**Agenda  
Planning Commission  
City Of Edina, Minnesota  
City Hall, Council Chambers**

**Wednesday, September 22, 2021  
7:00 PM**

**DATE:** 9/14/2021  
**TO:** Cary Teague – Planning Director  
**FROM:** Zuleyka Marquez, PE – Graduate Engineer  
**RE:** **313 Griffit St - Variance Review**

**DATE:** 9/10/2021  
**TO:** Cary Teague – Planning Director  
**FROM:** Zuleyka Marquez, PE – Graduate Engineer  
**RE:** **5615 Woodcrest Dr - Variance Review**

# CERTIFICATE OF SURVEY

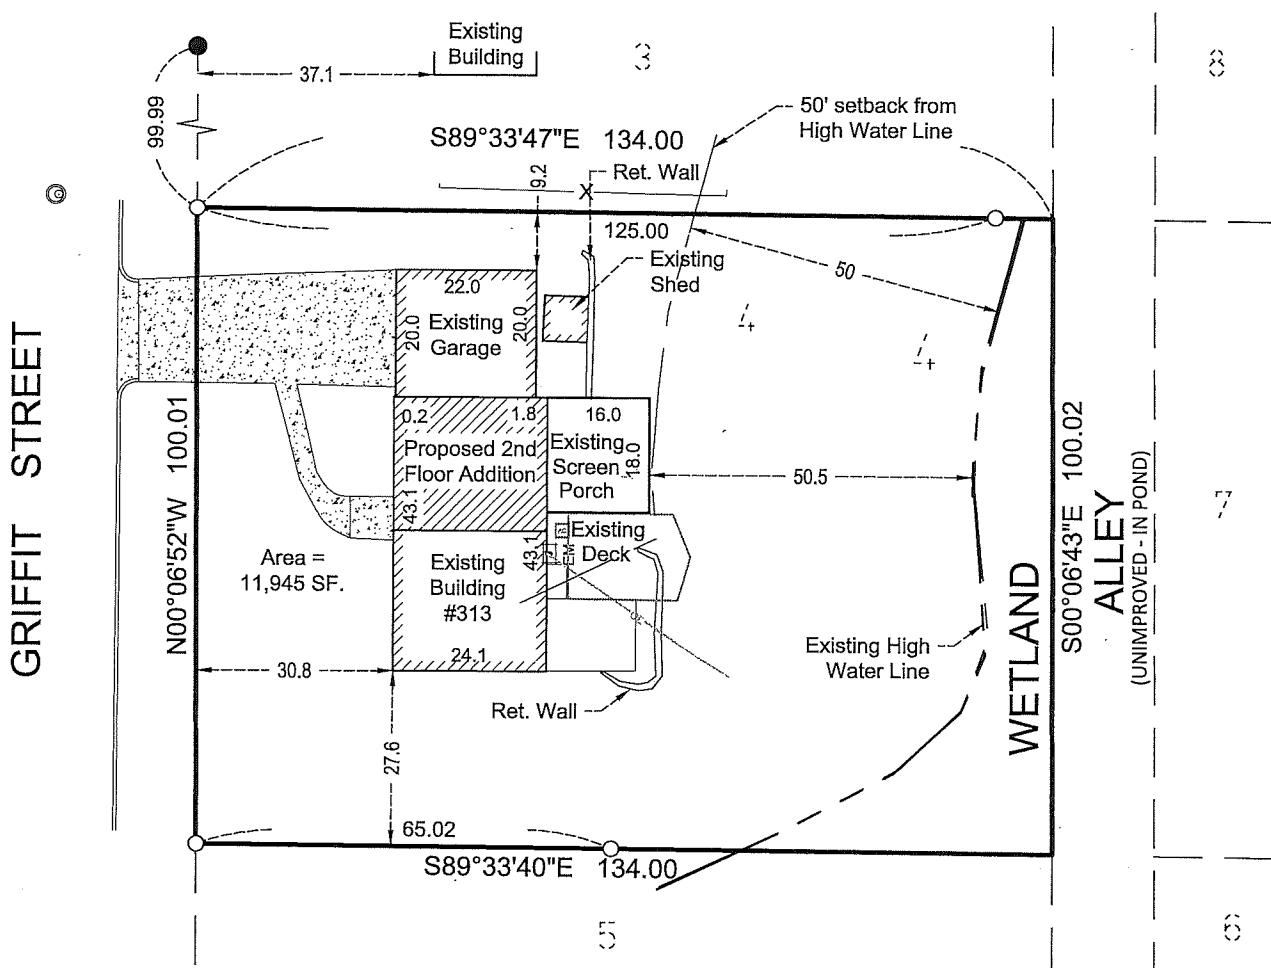
Show existing easement (for storage of water) on survey.

A local 1% annual chance floodplain and structural flooding issue with an elevation of 925.2' is located onsite. Provide proposed lowest opening elevation. Per sheet A1, new window casement proposed. Provide windowsill elevation on survey. Must be no less than 927.2'.
